# Waterloo Metro Quarter OSD Central Precinct (Building 2)

SSD-79307746

SSDA Response to Submissions

**Typical Co-Living Unit Plan**

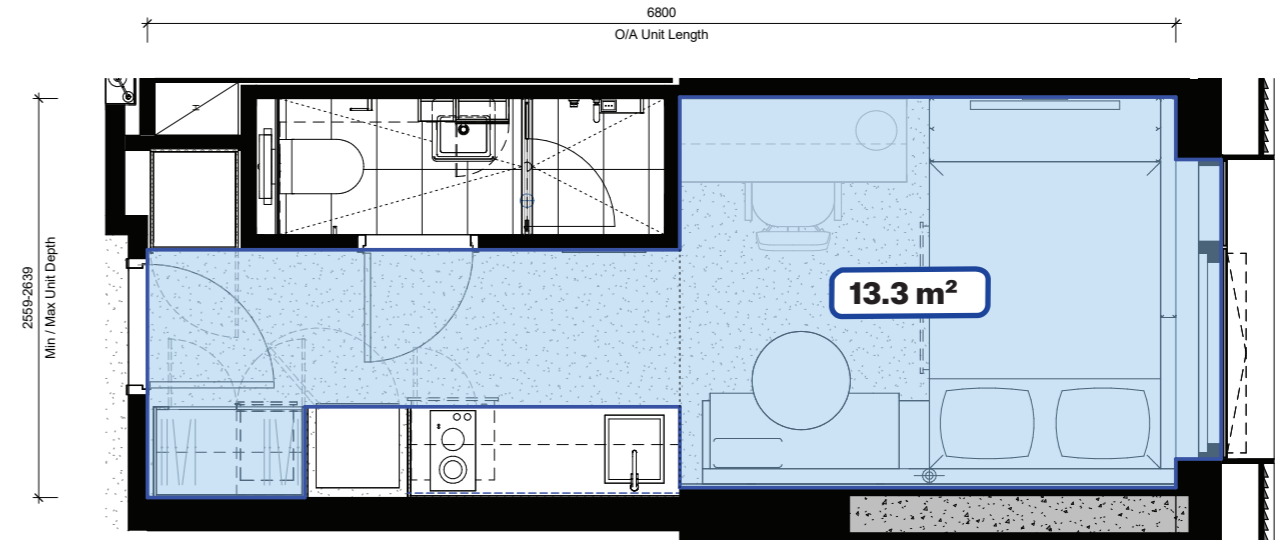
Provide information on the sizes of the proposed co-living units and demonstrate that the proposed units will achieve acceptable residential amenity with reference to the standards contained in Part 3 of Chapter 3 of the State Environmental Planning Policy (Housing) 2021 (Housing SEPP).

Typical units for a single occupant have a floor area of 13.3m<sup>2</sup> which is within the Housing SEPP acceptable range.

Premium units for dual occupants have a floor area of 28.5<sup>2</sup> which exceeds the maximum unit size by approx. 3m<sup>2</sup>.

There are a limited number of these unit types (~3%) and although co-living design standards do not apply to the site, it has been used as a guide.

Although co-living design standards under the Housing SEPP do not apply to the site, it has been used as a guide to inform design amenity. Majority of the units are compliant with the unit size requirements of 12m<sup>2</sup> - 25m<sup>2</sup>, excluding areas for the purpose of kitchen or bathroom.

There are a limited number of units (~3% total) which exceed the maximum unit size by approx. 3m<sup>2</sup>. Offering varied unit size supports diversity in housing choice, and it recognises that people who choose co-living are not all the same, and that their needs change over time.

**Accessible Co-Living Unit Plan**  
1:50 @ A3

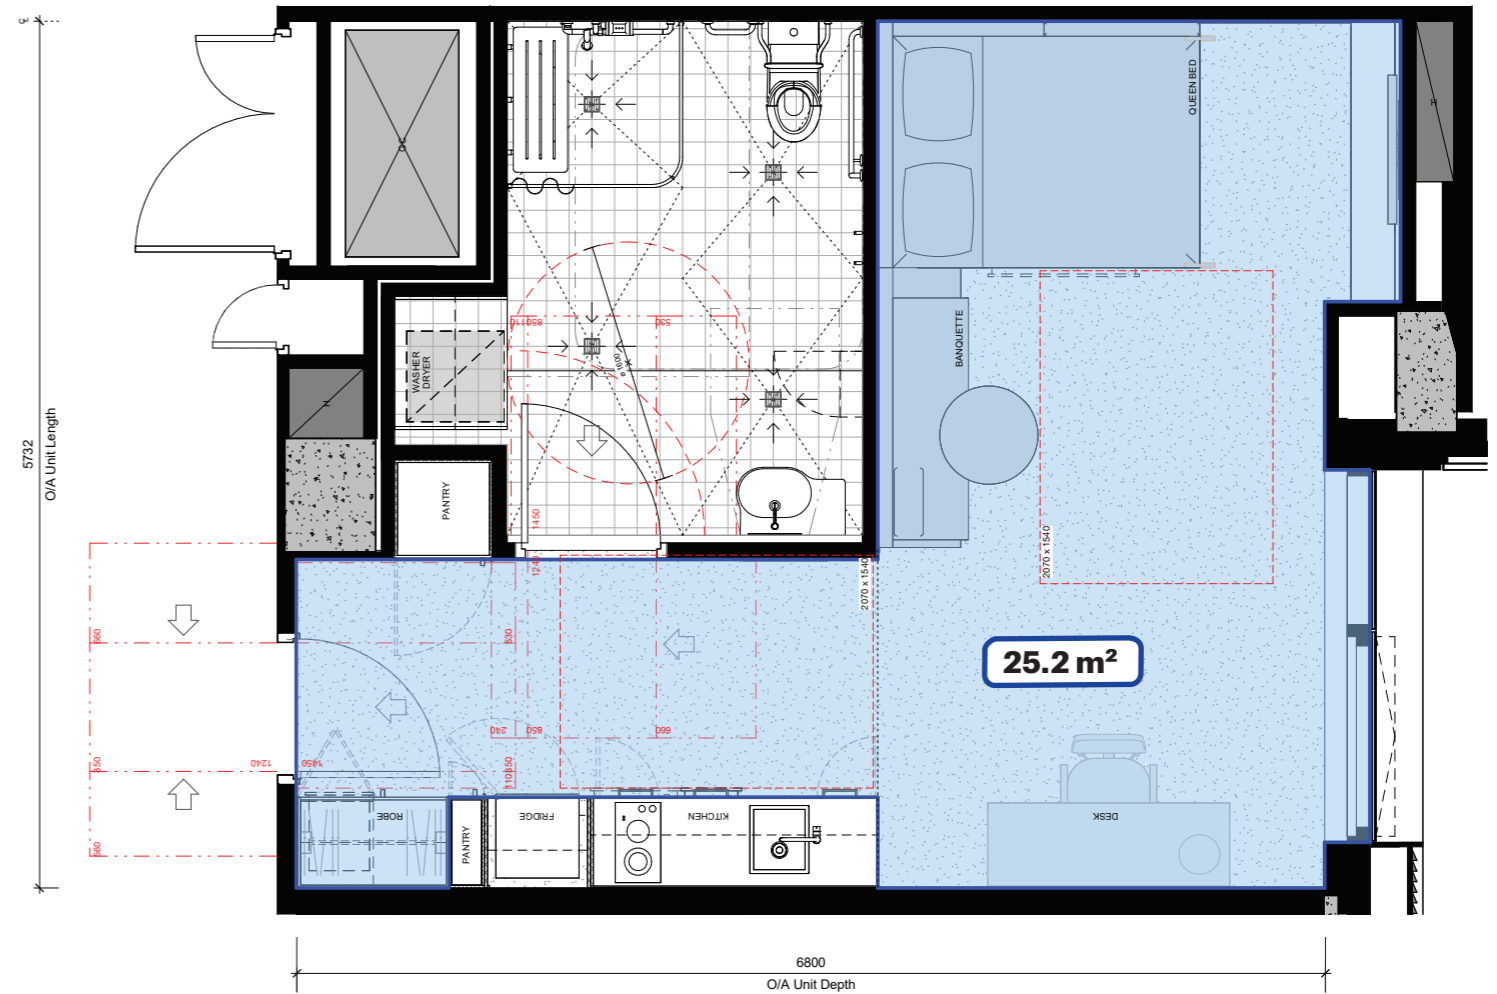
Provide information on the sizes of the proposed co-living units and demonstrate that the proposed units will achieve acceptable residential amenity with reference to the standards contained in Part 3 of Chapter 3 of the State Environmental Planning Policy (Housing) 2021 (Housing SEPP).

Accessible units have a floor area of 25.2m<sup>2</sup> which is at the upper limit of the Housing SEPP acceptable range.

The accessible unit size is informed by the requirements for equitable access and further contributes to the diversity of housing within the development.

**Ground Level Site Plan**  
1:600 @ A3

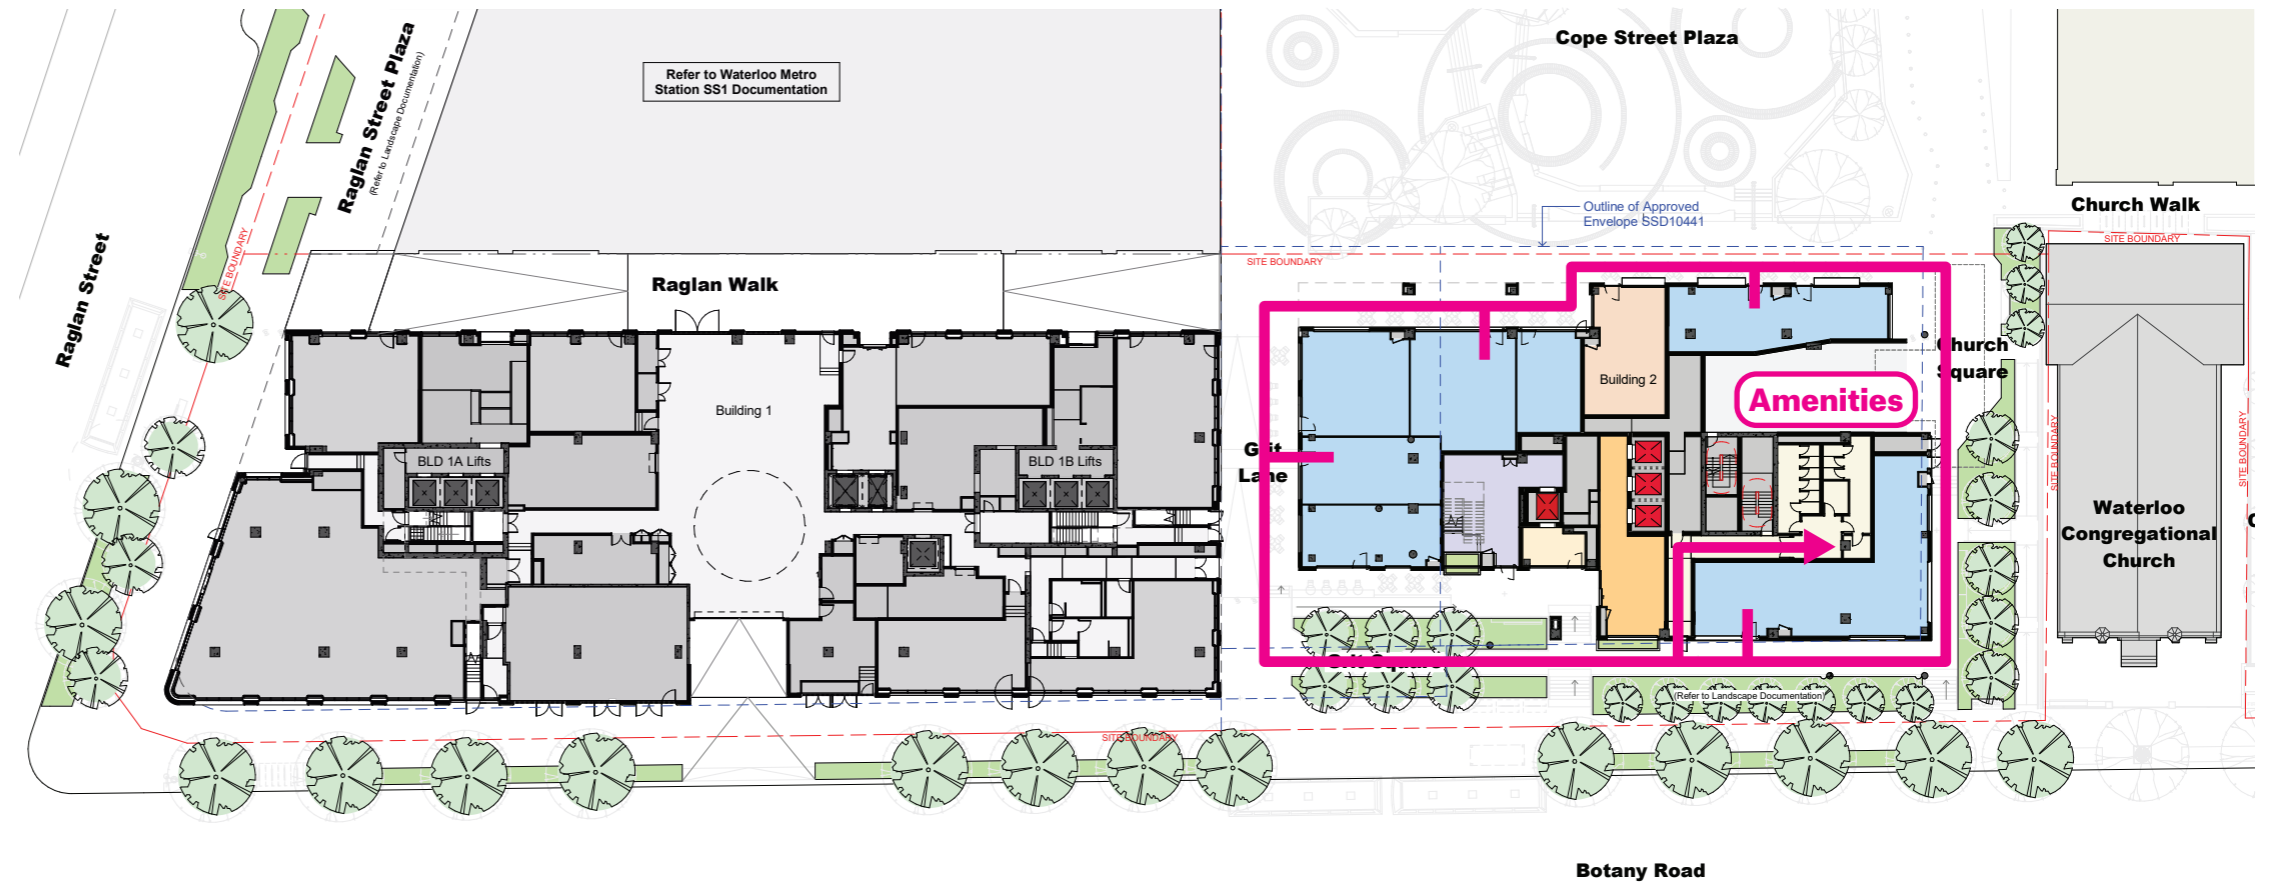
Review the design of ground floor /retail layouts of the Northern and Central Precinct to achieve equitable access to shared amenities / back of house areas; and

address SDRP advice on Site Strategy and Built Form Point 8: Ensure that the serviceability of the retail offerings is considered during design development. For example, access to shared amenities , ventilation requirements and kitchen exhausts.

Ground level shared amenities are centrally located to ensure convenient and equitable access for all retail tenancies.

The location is separated from vehicular paths to promote pedestrian safety and the entrance benefits from clear visibility from the public domain.

**Ground Level Site Plan**

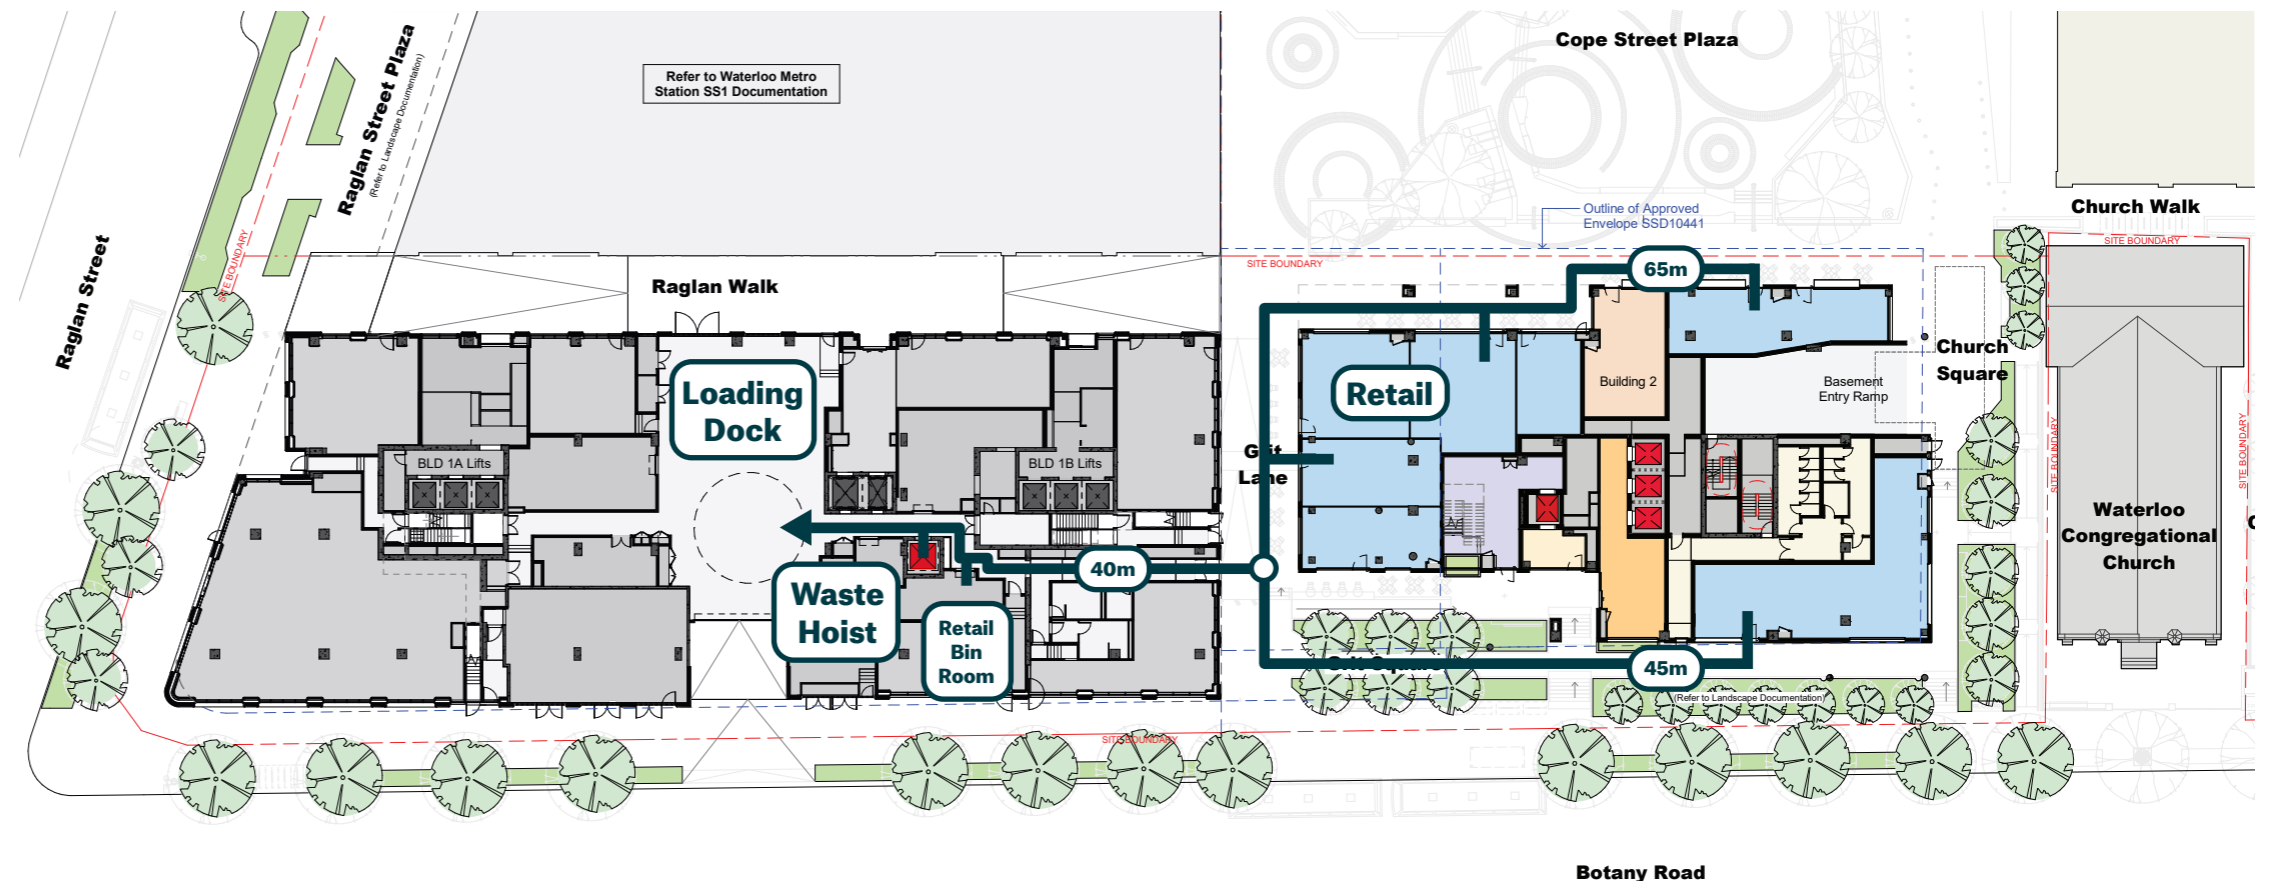
Review the design of ground floor /retail layouts of the Northern and Central Precinct to achieve equitable access to shared amenities / back of house areas; and

address SDRP advice on Site Strategy and Built Form Point 8: Ensure that the serviceability of the retail offerings is considered during design development. For example, access to shared amenities , ventilation requirements and kitchen exhausts.

All waste collections will occur onsite from the shared loading dock at ground level.

Retail waste will be transferred at ground level between tenancies with a shared retail waste room located near the loading dock.

An allowance has been made for three (3) 3000 L/s exhaust risers serving the ground floor retail tenancies, providing capacity for future food and beverage uses.

View across Cope Street Plaza

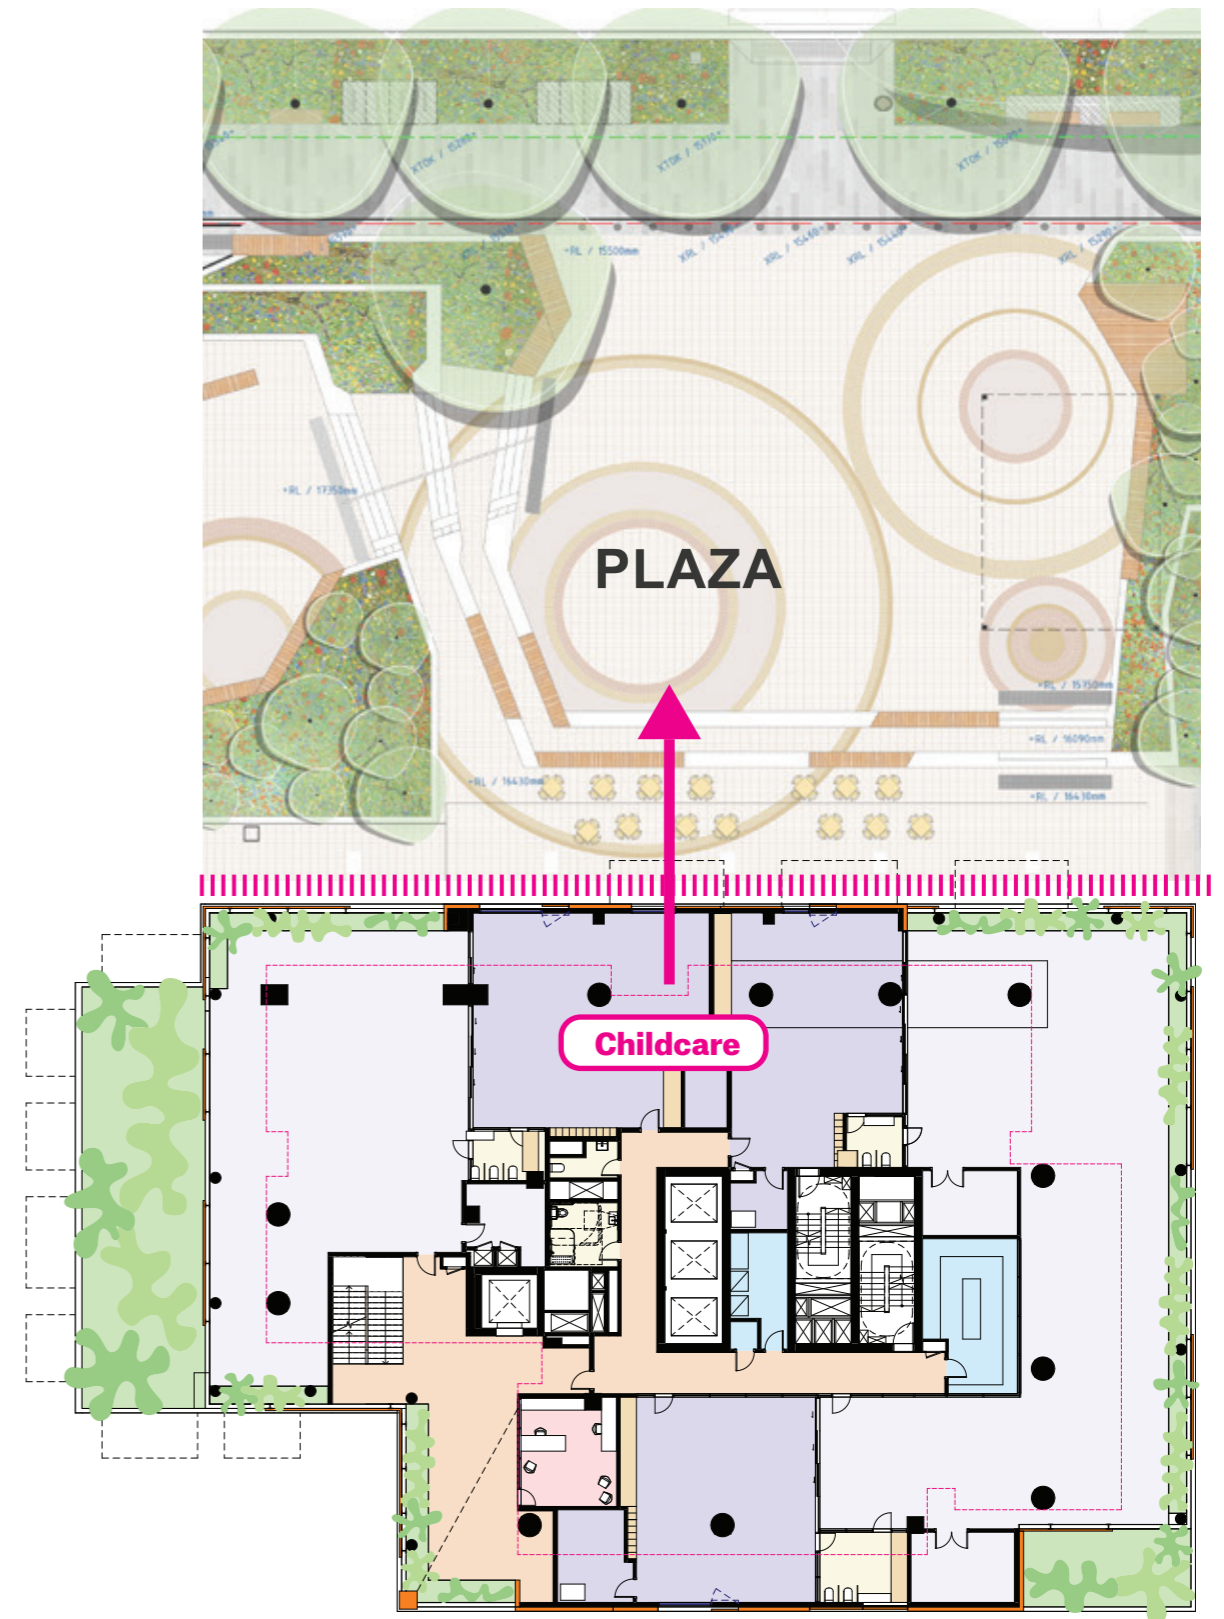
Provide a copy of the site-specific Connecting with Country Guidelines, as prepared by Murawin, including an assessment of the proposal's design response to each of the guiding principles; and

address SDRP's advice on Connecting with Council Point 1: Further exploration of community engagement and empowerment opportunities within the design and operation of the development is encouraged. A document outlining how indigenous business empowerment and co-design will guide the project's design and operation should be developed.

Centrally located at the heart of the Waterloo Metro Quarter, the childcare facility engages the public domain and maintains direct visual connections to the Cope Street Plaza, where public art is integrated within the plaza.
